**Flood Control Project Maintenance
Levee Inspections**
LMA District Cover Sheet
Spring 2018 Levee Inspection Results

Sacramento Maintenance Yard Cache Creek

Spring 2018 Levee Inspection Results

Waterway			Bank	Unit Miles
Unit No. 01 North Levee			Left	11.69
	Spring (March - May)	Summer (June - August)	(September - November) Fall	Winter (December - February)
Unit Maintenance Rating (Fall Only)				
Date of Inspection	3/6/2018 - 3/6/2018			
DWR Inspector	Zach Jojola			
Accompanied By

Photo 3 of 3 : SP_2018_ST0001_259_3_20180306_00004.jpg

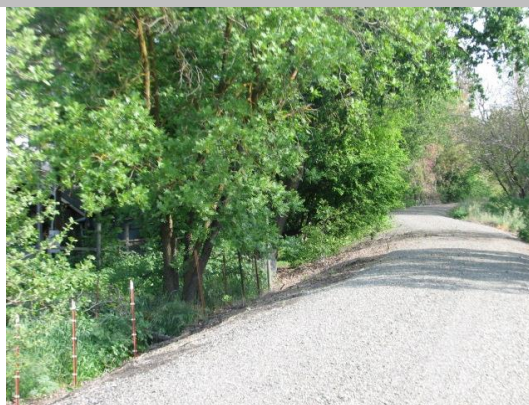
LM Start	1.90	Rating **	M	Issue No.	3 (cont)	
LM End	1.98	Issue Type +	En	Location *	LS	
Category	Earthen Levee			GPS Latitude/Longitude		
				Start		End
Item	Vegetation			38.730008 °		38.731170 °
				-121.806497 °		-121.806220 °
DWR ID	DWR_ST0001_01_s_2012_3					
Comment Code						
V6 : Landscaping						
Inspector Comment

The landscape needs to be trimmed up. Spring 2014

Photo 1 of 2 : UCIP_SP_2018_50811_60197.jpg

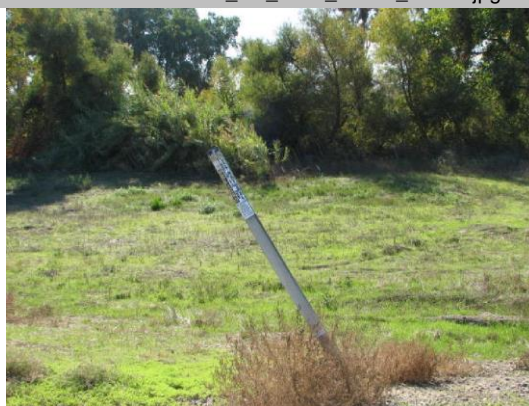
LM Start	7.89	Rating **	M	Issue No.	87
LM End	7.89	Issue Type +	En	Location *	
Category	Supplemental			GPS Latitude/Longitude	
				Start	End
Item	DWR UCIP Field Study			38.727333 °	38.727333 °
				-121.718558 °	-121.718558 °
DWR ID					
Comment Code					
Inspector Comment					
FS_ID:50811 DS_ID:16264 EP_NO: 12983 Repair Type: Non-Urgent Crossing Status: Indicator Found UCIP Comments: Gasline markers in disrepair and should be replaced. Gasline indicator found on waterside of the levee. FIELD_STRUCT_DESC: 4-inch and 6-inch coated steel natural gas pipelines through the levee and under the Cache Creek Settling Basin, at an unknown depth. (4-inch and 6-inch pipelines authorized under Permit No. 12983, 1980 - Shell Oil Company). [Additional Reference(s): DWR Levee Log, 1993]. FS Date: 11/21/2016 7:56:33 AM

Waterside view: gasline indicator
